3.2 Water Resources

Figure 3.4-1

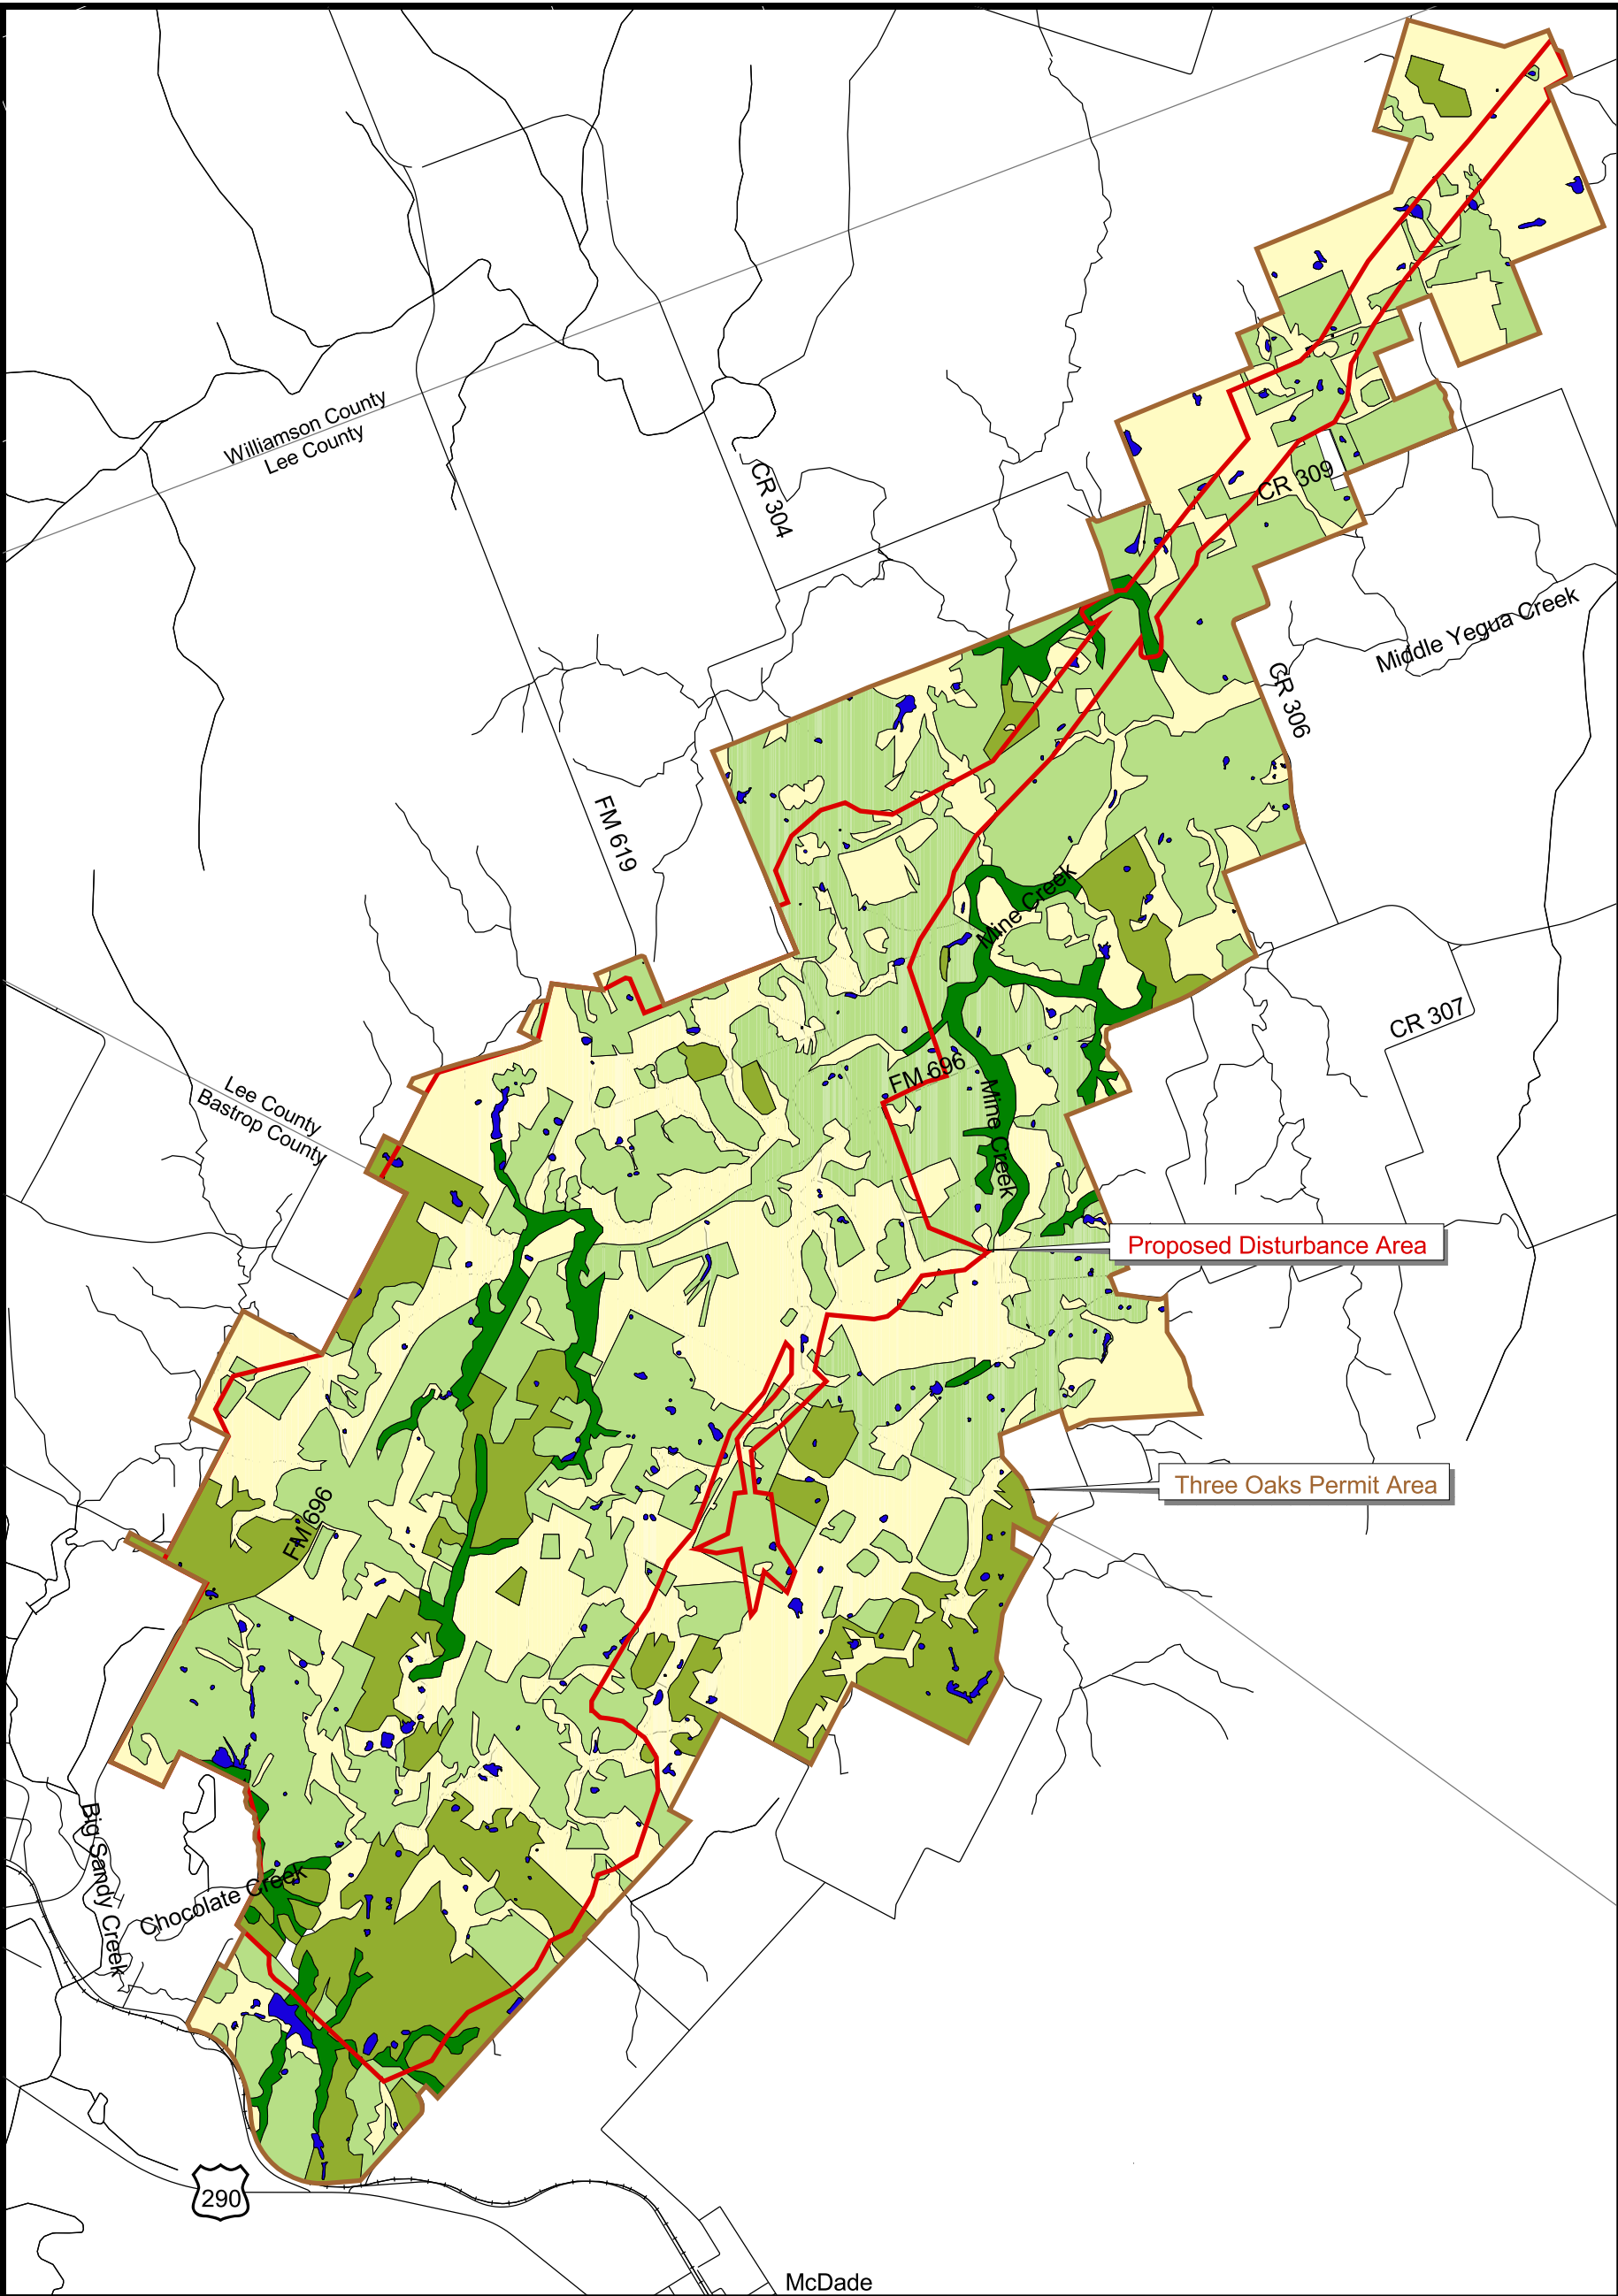
Figure revision: Revised disturbance area for
transportation and utility corridor crossing of Middle
Yegua Creek.
